MEMORANDUM

To: Adriaan Rossouw, Mpho Mathelele
Cc: Riaz Essack, Thabo Mokgalanyane, Russel Aschmann
From: Nathaniel Seseletsi
Date: 30 January 2019
Subject: Pier No 23 on Elevated road at ORTIA

Figure 2: Cracking on Pier 23

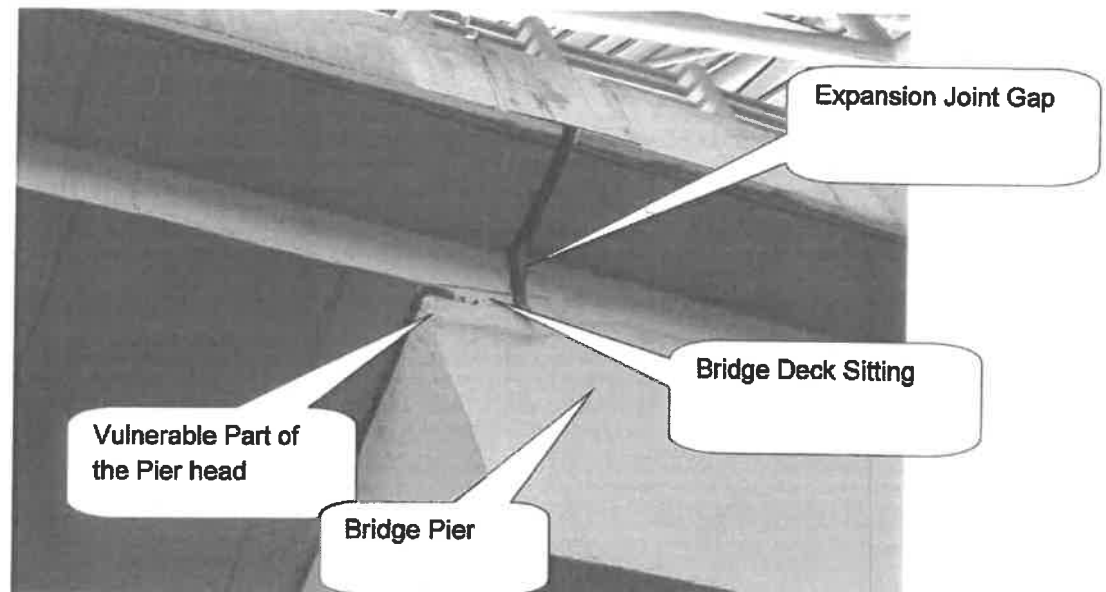
My findings are that cracks are structural in nature, however they do not affect the structural integrity of the Bridge. The cracks are caused by the Bridge deck bearing directly on to the pier head and the Bridge expansion gap closed by mortar. This defect resulted from bad construction of the Bridge as the Bridge deck was constructed to rest directly on the vulnerable part of the Pier head, this area is vulnerable due to the fact that the concrete at the tip is not reinforced due to cover requirements, furthermore the Bearing Strip seems to be omitted resulting in concrete bearing directly on concrete, Figure 2 below provides an example of how the Bridge should have been constructed

Figure 3: Close Up on Pier 23

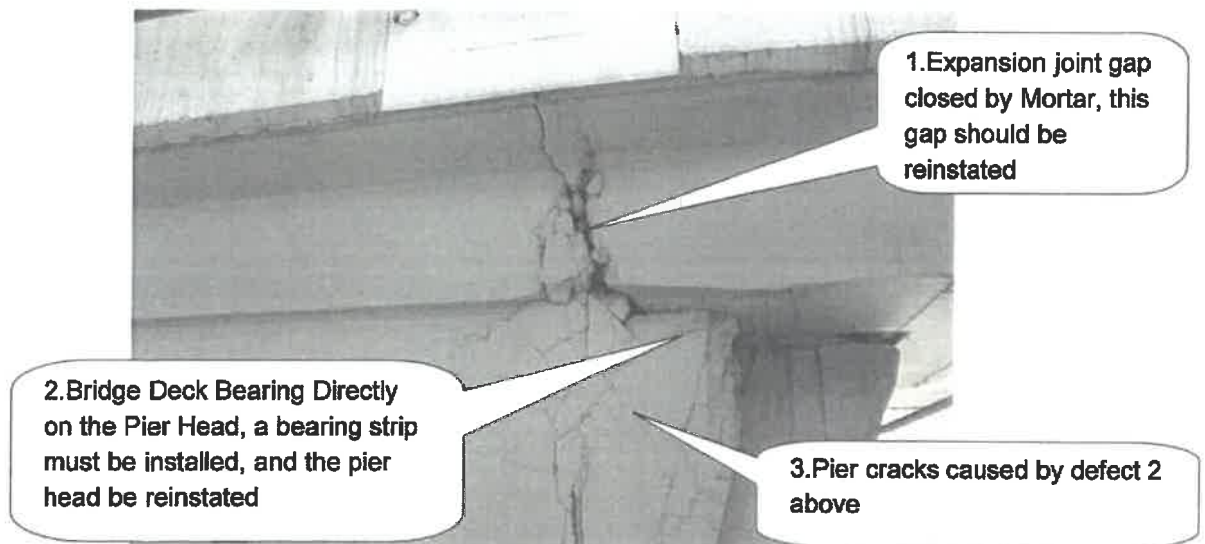
Figure 3 below is a close up on the defects on Pier 23, the expansion joint gap was closed by mortar and it is cracking due to bridge movement, the expansion joint gap needs to be reinstated to allow the bridge to move freely.

- (a) All the loose and spalled concrete and mortar be removed from the Bridge deck and the Pier head
- (b) The bridge ends be neatly finished with mortar (Note: The expansion joint gap should remain open)
- (c) Apply wet to dry epoxy to the exposed surface of the Pier head, then shutter the pier and pour in flowable concrete
